1958 Agreement – Consideration of draft amendments to existing Regulations submitted by GRSG

Proposal for the 04 series of amendments to Regulation No. 107 (M₂ and M₃ vehicles)

Submitted by the Working Party on General Safety Provisions*

Model A

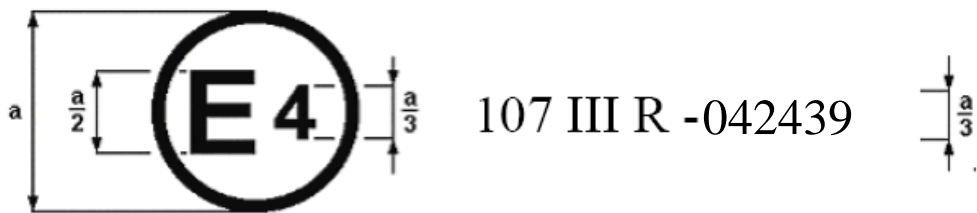
Annex 2, amend to read:

The above approval mark under approval number 042439. The approval numberas amended by the 04 series of amendments.

Model B

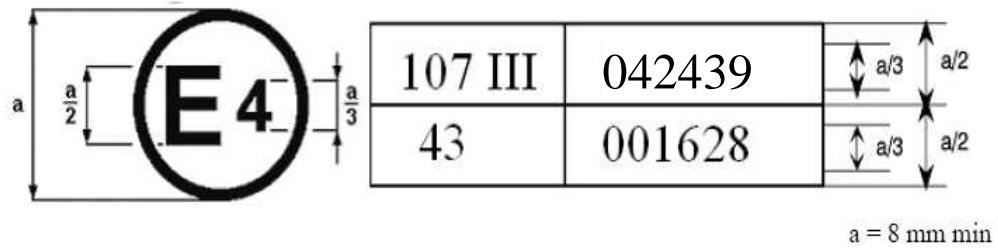
The above approval markRegulation No. 107 included the 04 series of amendments and Regulation No. 43 was in its original form.

Model C

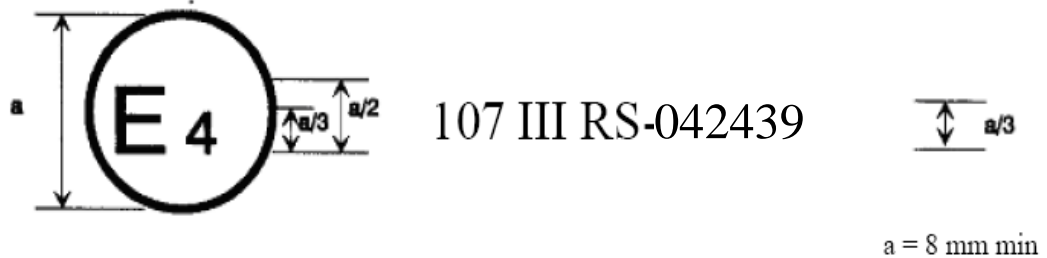
The above pursuant to Regulation No. 107 under approval number 042439. The approval number indicates as amended by the 04 series of amendments."
